The ISO received comments on the topics discussed at the October 31, 2016 stakeholder call from the following:

# Stakeholder Comments California ISO 2018 Local Capacity Technical Study Criteria, Methodology and Assumptions Call Stakeholder Comments October 31, 2016

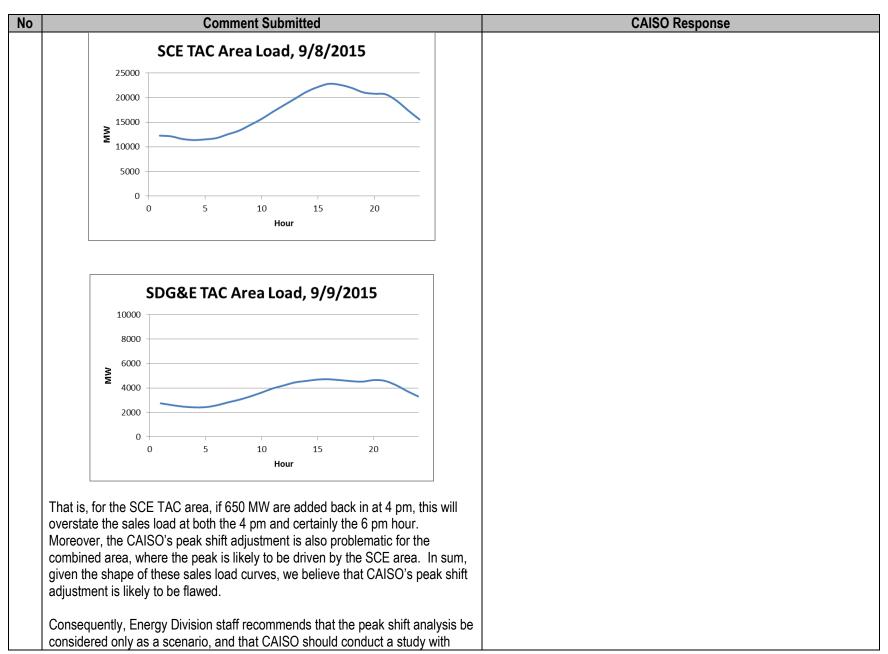
In its Draft Manual, CAISO states that "The ISO will continue to perform additional assessments of the reliability impacts when loads continue to remain high as forecasted by the CEC, but without the contribution of solar photovoltaic distributed generation at an early evening hour (i.e., 6:00 p.m.)."	
	Energy Division staff finds the CAISO's methodology, of adding back in all of the behind-the-meter generation (i.e. 254 MW for SDG&E and 733 MW for SCE for 2018) to the CEC's base case forecast to be flawed as it overstates the loads in these areas. CAISO's methodology is flawed because it does not take into consideration that consumption loads decline by 6 pm and, therefore, adding back in behind the meter generation to the 4 pm peak will result in a higher load than will be seen at the 6 pm hour. This is illustrated in the figures below.

No	Comment Submitted	CAISO Response		
	only the CEC <b>adopted</b> forecast and with the assumption that Aliso Canyon is operational (to ensure comparability and to ensure that the CPUC is able to adopt LCR needs if Aliso Canyon is operational, without the peak-shift <b>scenario</b> , if appropriate).			
1j	CAISO Should Use a Coincidence Adjustment for its Combined LA Basin/San Diego Area  On the stakeholder call, CAISO appeared to indicate that it was using a coincidence adjustment for the combined LA Basin and San Diego sub-area	Based on the ISO's review of peak load data, the LA Basin and San Diego areas tend to peak at approximately the same time. The following are a few examples where peak loads are either peaking at the same (with one or days apart) or same day with less than half hour difference.		
	analysis. We agree that the load should be adjusted for coincidence, but are not	PTO	Peak Load (MW)	Hour Ending
